BULLETIN 6723

PJB RED HEADLIGHT ASSEMBLY NON- CONFORMANCE

BULLETIN PJB Headlight Fitting Non Compliance

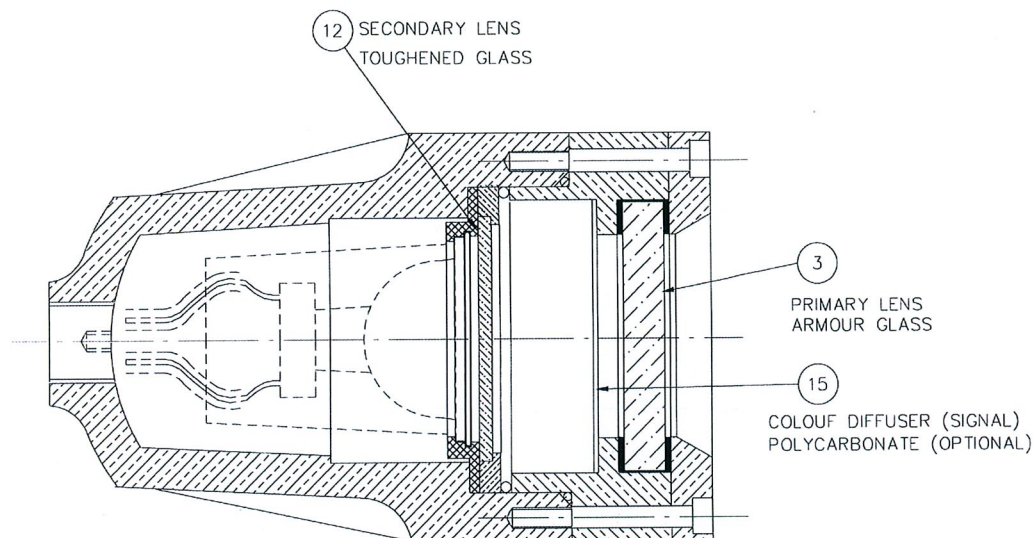
GE Industrea has been notified of a non compliance issue with the assembly of the Red PJB Headlight M28300.

The secondary lens (item 12) sits in front of the headlight globe inside the flameproof enclosure. Red lights have an 'Optional Colour Diffuser' (item 15) that sits behind the headlight enclosure's primary lens (item 3). Close inspection has found a batch of lights have been assembled with a red coloured secondary lens approximately 2.5mm thick, installed instead of a clear 4 mm glass.

GEI recommend that PJB Headlights be inspected to determine if the assembly of red lights are in compliance with the AUS Ex 983X Certificate of Conformity. Suitably qualified personnel are required to undertake the inspection in line with the requirements of AS3800.

Please contact GE Industrea for supply of secondary lens (4mm clear toughened glass) and colour diffuser (red polycarbonate disc).
